ITEM FOR ENVIRONMENTAL COMMISSION AGENDA

COMMISSION MEETING DATE: February 5, 2020

NAME & NUMBER OF PROJECT: XSpace Group
SP-2019-0189D

REQUEST: Variance request is as follows:

XSpace Site Plan

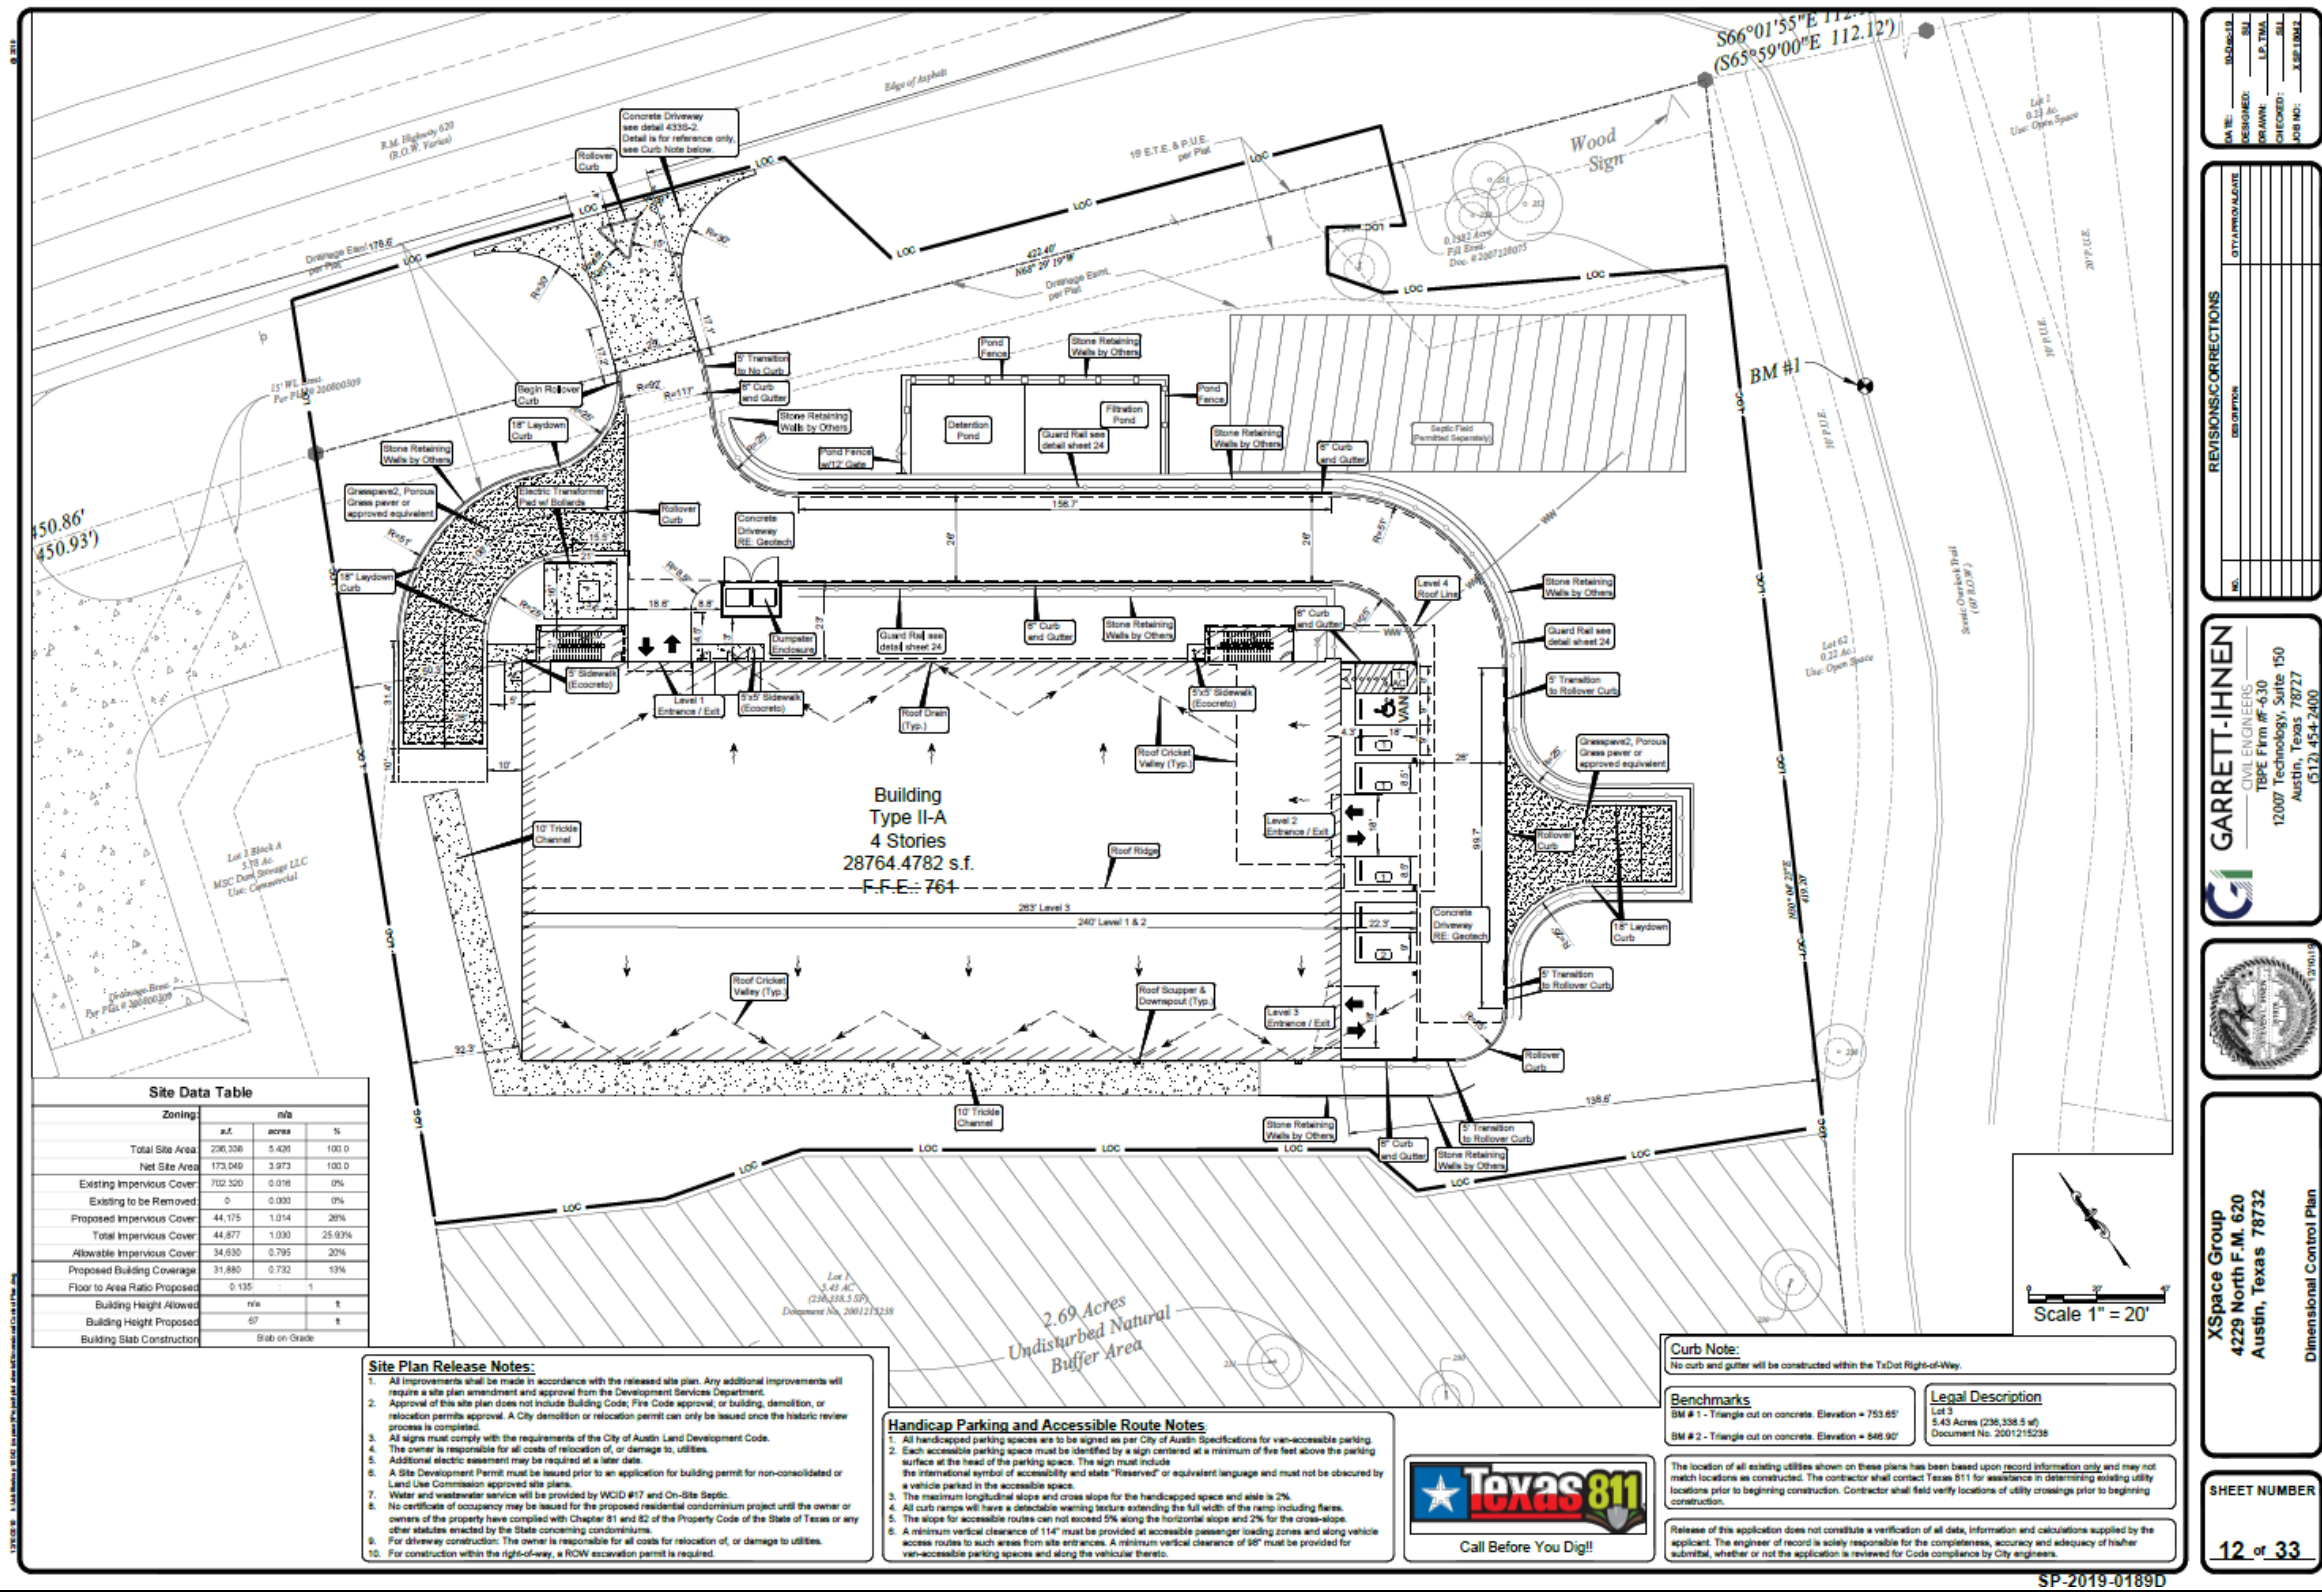
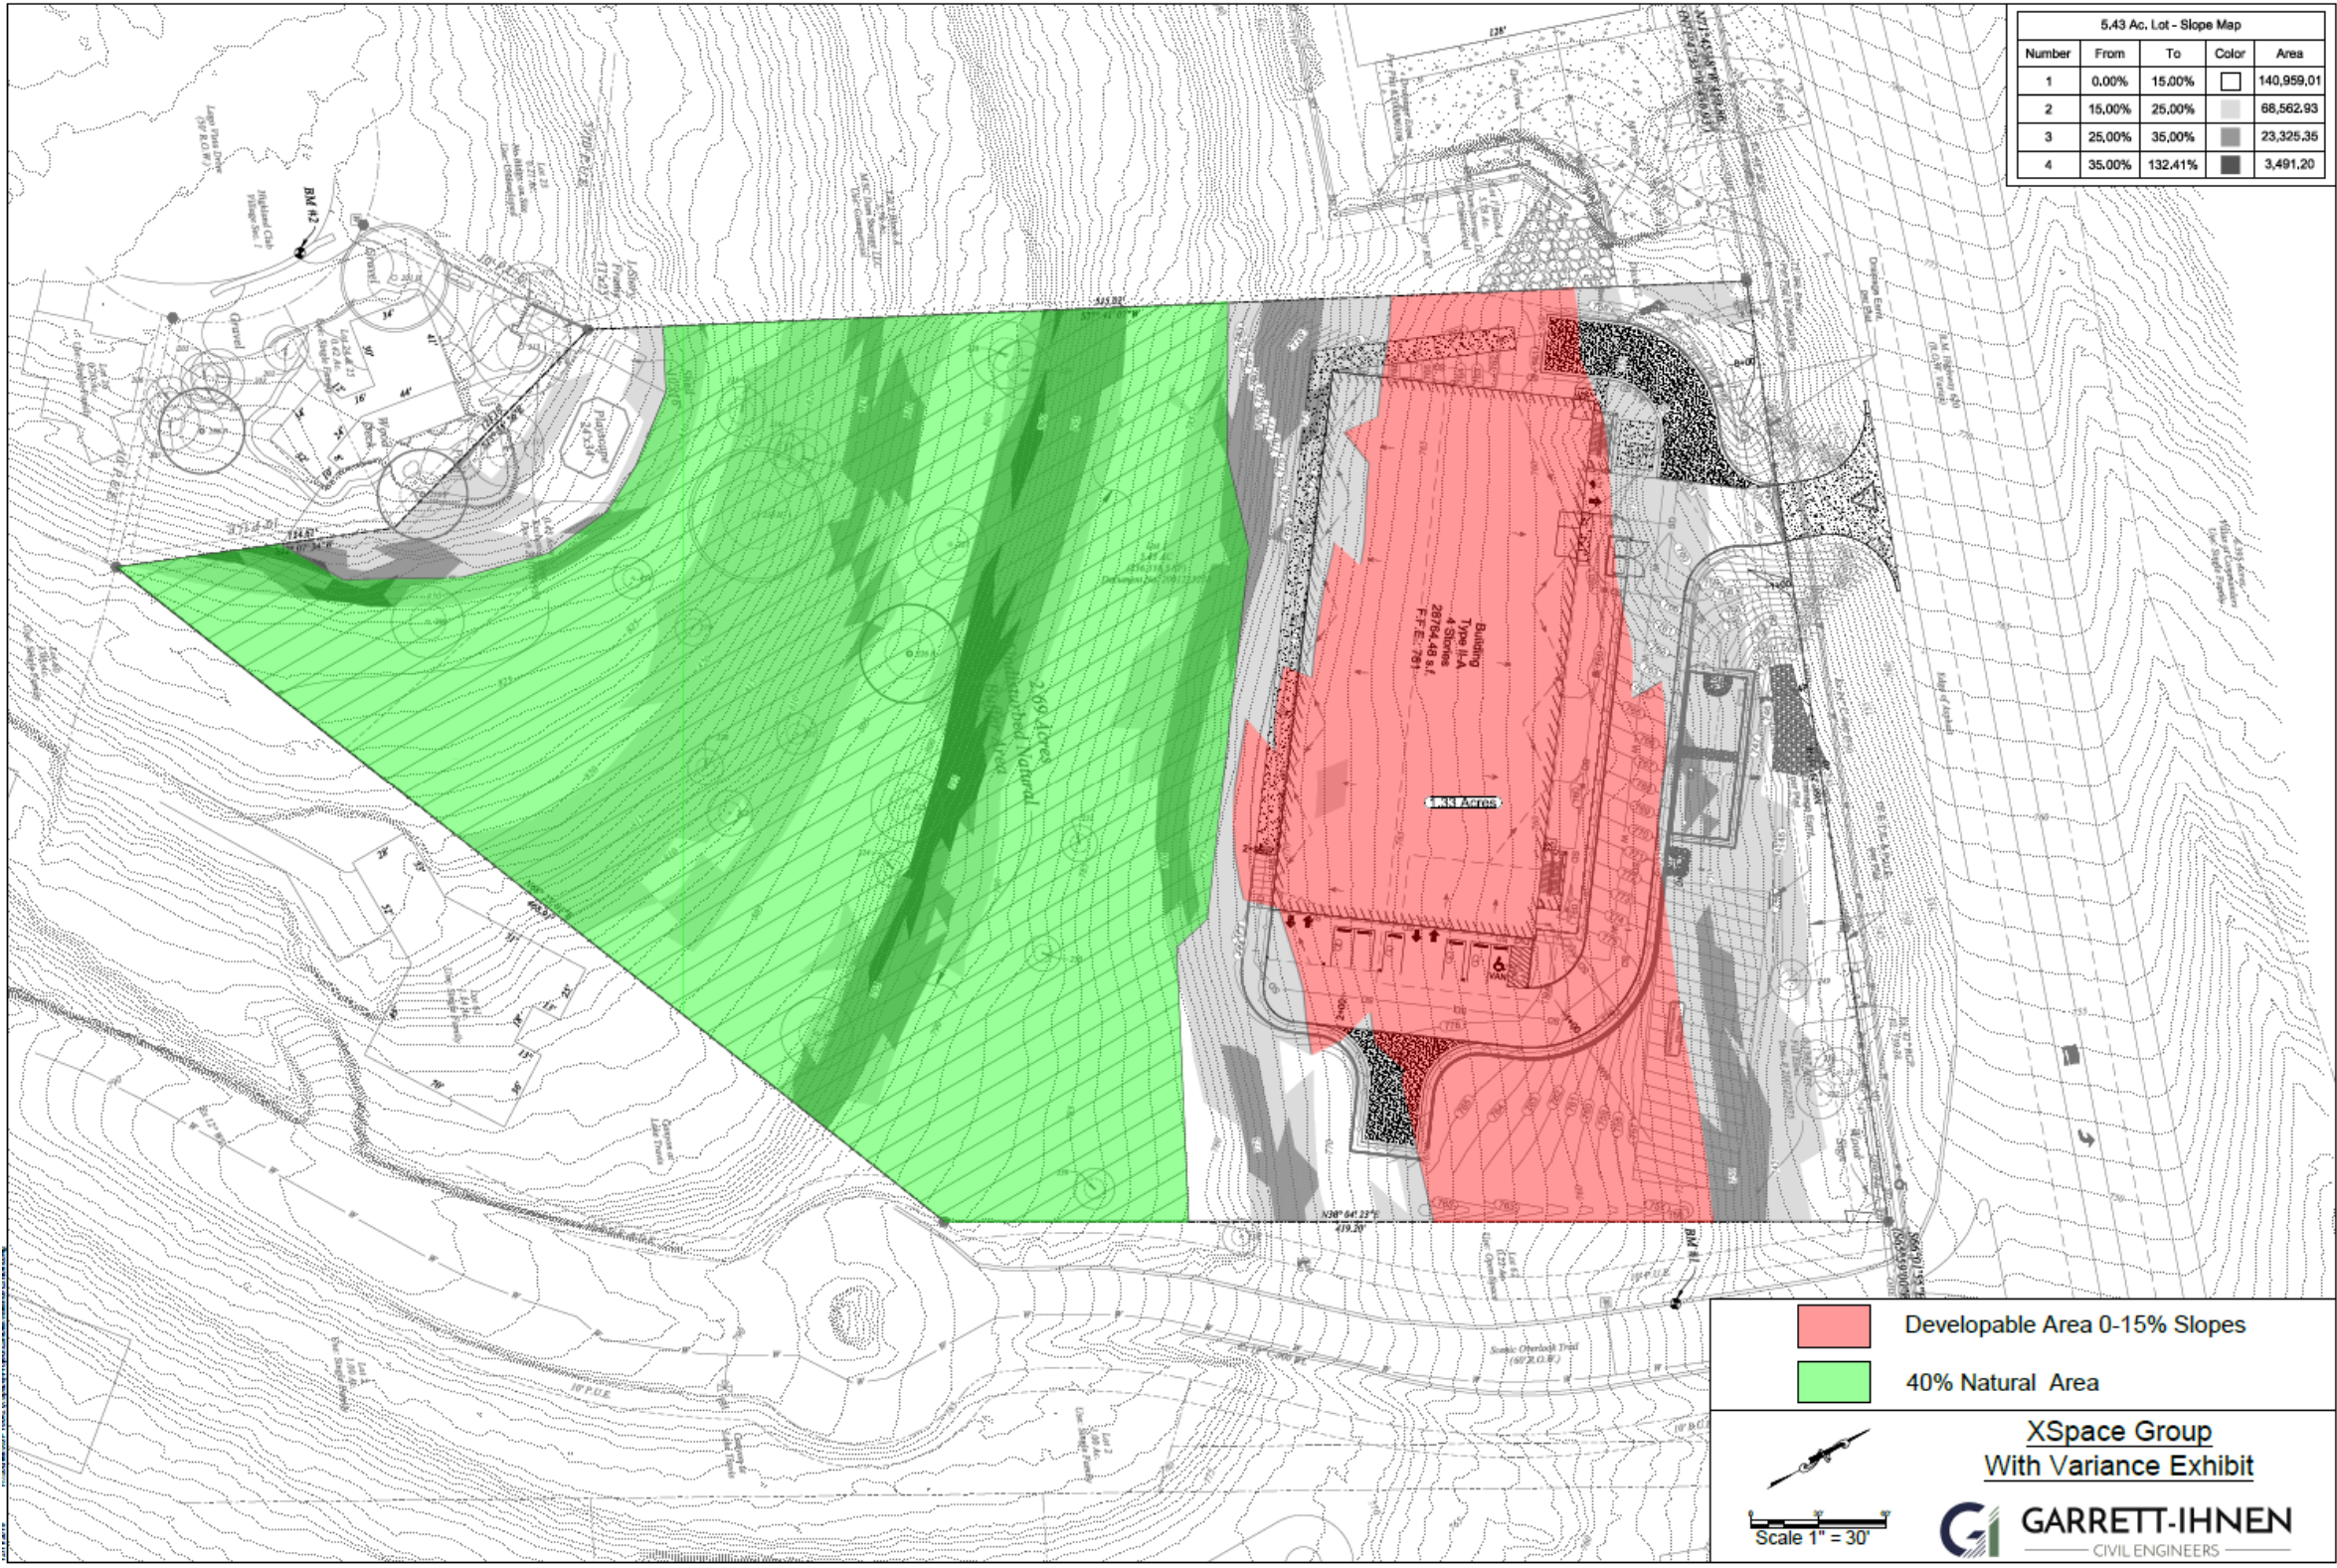
Yes. Code and Criteria allow a driveway to be constructed on slopes over 15% when the driveway provides primary access to a minimum of two contiguous acres of land with a slope less than 15 percent. However, the topography of the property is

characterized by alternating bands of slopes less than 15 percent and slopes greater than 15 percent (see slope exhibit, p. X). Collectively, there are over three acres of land with slopes less than 15 percent, yet they are not contiguous. The proposed driveway is directly perpendicular to FM 620, and is located on the narrowest band of slopes in excess of 15 percent. This allows for the remaining portion of the development to be located on an area of approximately 1.33 acres of land with slopes less than 15 percent. The variance is based on the development's requirement to access the buildable land and to comply with vertical slope requirements set forth by Austin Fire and Travis County Fire and Rescue. If the driveway were proposed elsewhere along the property frontage, it would have to cross slopes in excess of 25 percent gradient, and would locate other development on slopes steeper than 15 percent.

Yes. No significant trees or vegetation will be removed for the construction of the driveway, the driveway is not proposed to cross a naturally occurring waterway, and there are no critical environmental features (CEFs) present that will be impacted by the construction of the driveway.

Yes. The fill required to construct the driveway on slopes will be structurally contained to minimize or eliminate any erosive flows post-construction, and appropriately sized culverts will be included to allow offsite flows to continue through the site in accordance with existing conditions.

1. Compliance with LDC 25-2, Subchapter C, Division 3, §25-2-1024 and restore the vegetated area in front of the structural retaining walls with a dense massing of native trees, shrubs, and grasses;

XSpace Cut/Fill Exhibit

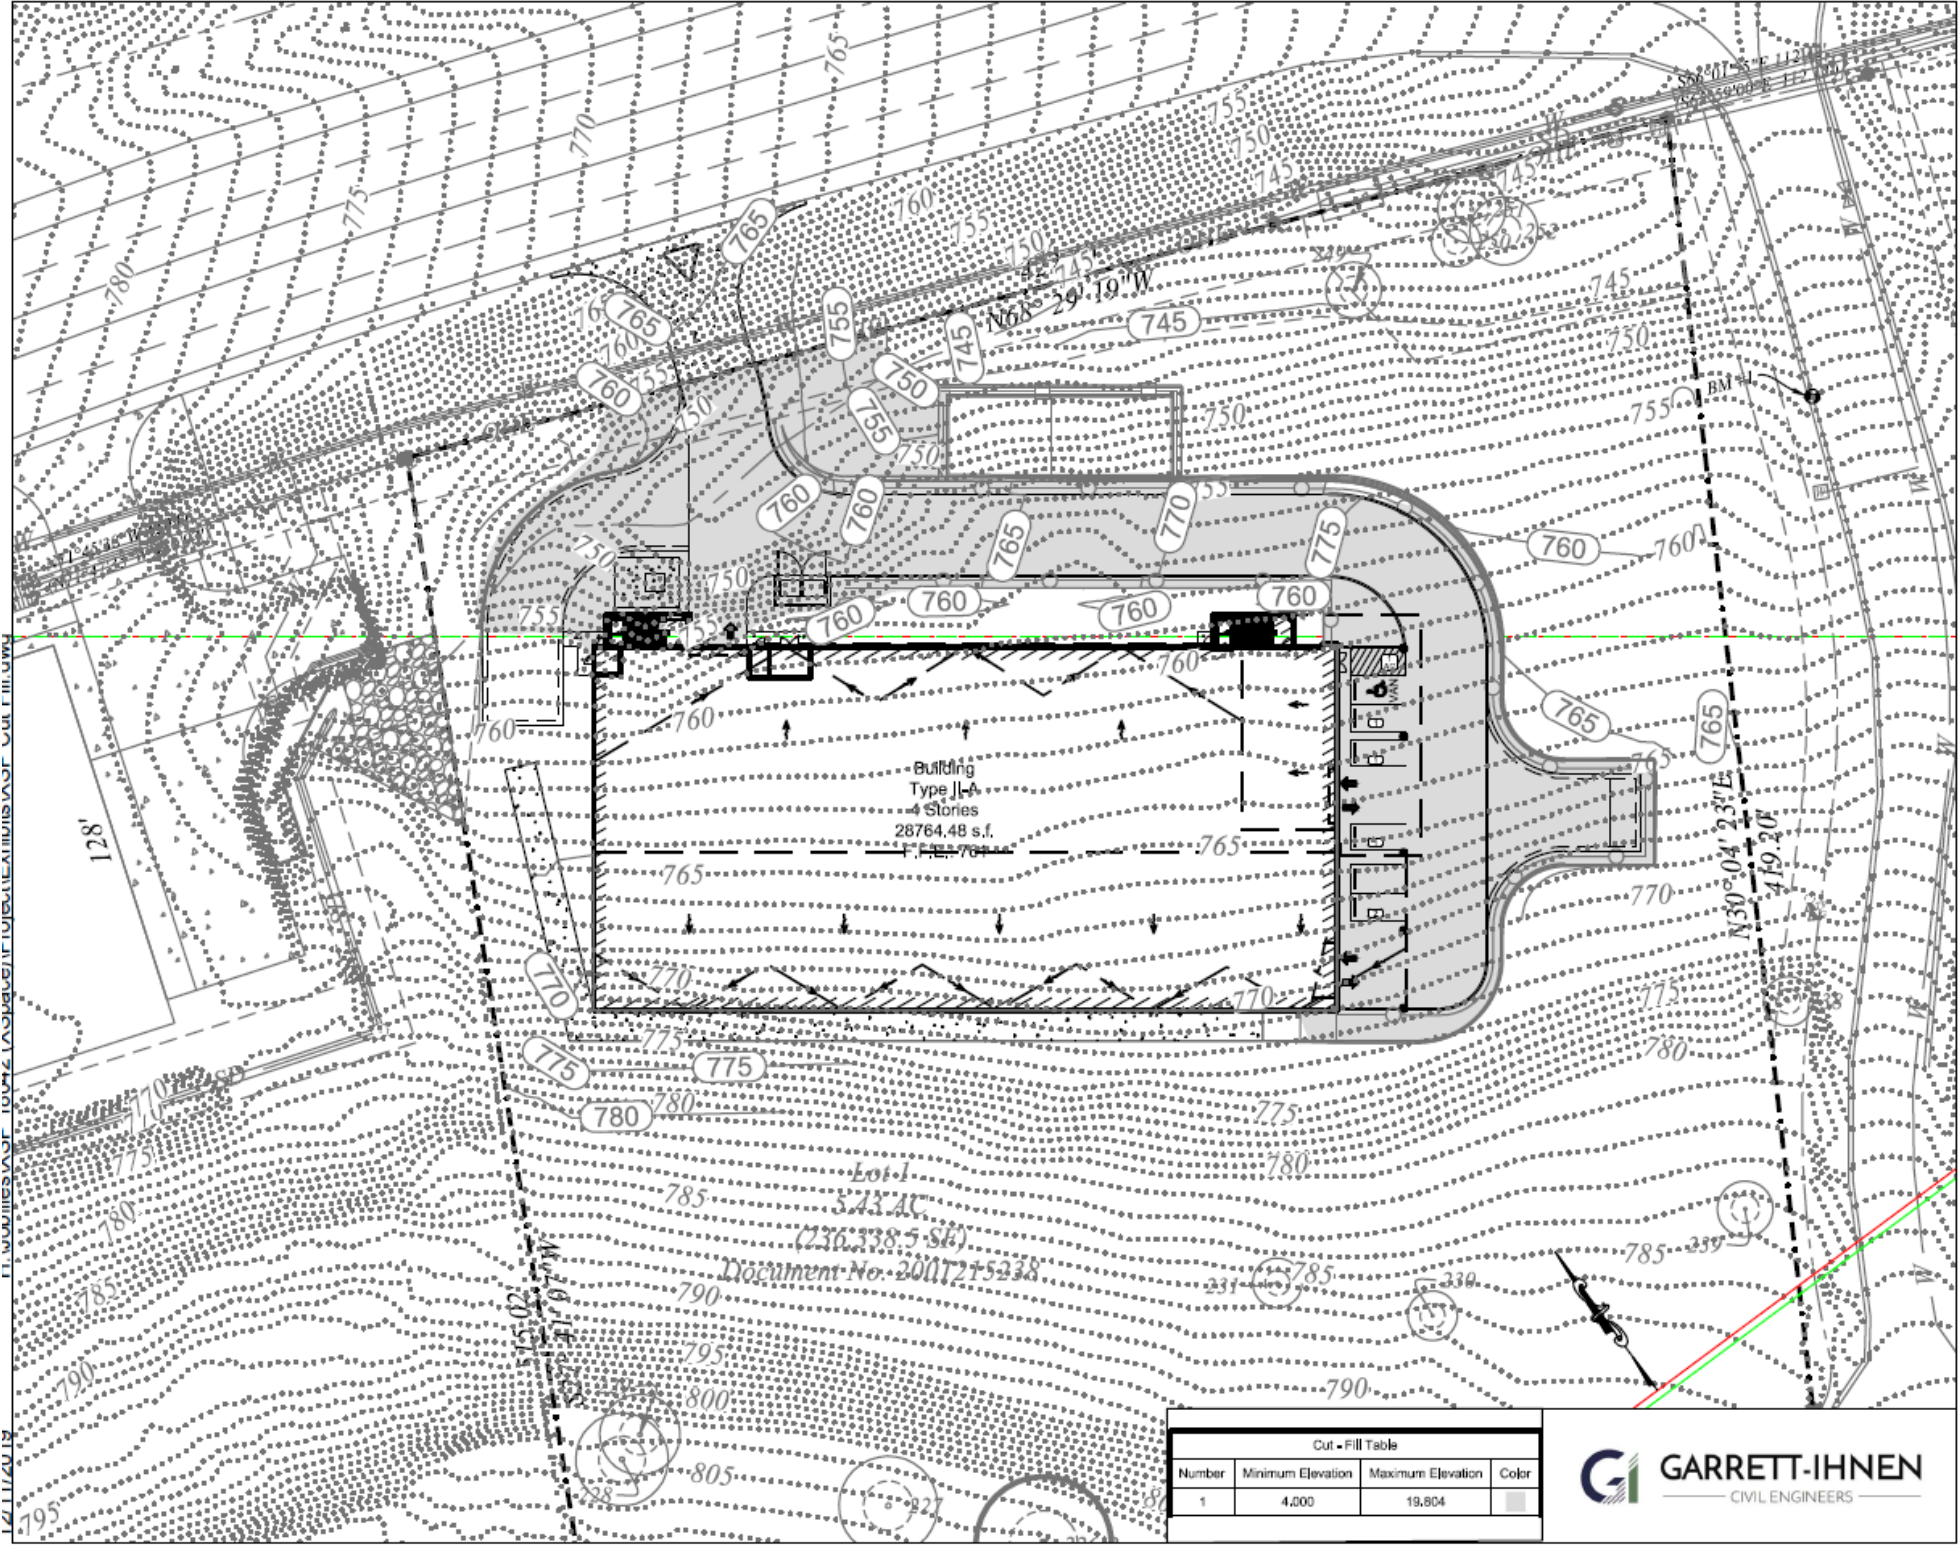
Yes. The only access into the property is from FM 620, which, at the time of its construction elevated the roadway far above the existing contours of the site. The topographic difference between the roadway elevation and the property line is approximately 20 feet. As such, to meet vertical curvature guidelines for emergency access, the additional fill is needed for construction of the driveway. The property is bound on all other sides by private development, and there is not an alternative point of access into the property.

Yes. The excess fill is required to meet vertical curvature requirements set by Austin Fire Department and Lake Travis Fire and Rescue.

Yes. The excess fill proposed is only at an elevation necessary to meet vertical curvature requirements set by Austin Fire Department and Lake Travis Fire and Rescue, and the majority of the required fill is structurally contained with concrete retaining walls.

Yes. The majority of the required fill is structurally contained with concrete retaining walls, thereby eliminating the need for an excess volume of fill material to meet 3:1 back slope requirements, and reducing the probability of erosive flows.

1. Compliance with LDC 25-2, Subchapter C, Division 3, §25-2-1024 and restore the vegetated area in front of the structural retaining walls with a dense massing of native trees, shrubs, and grasses;
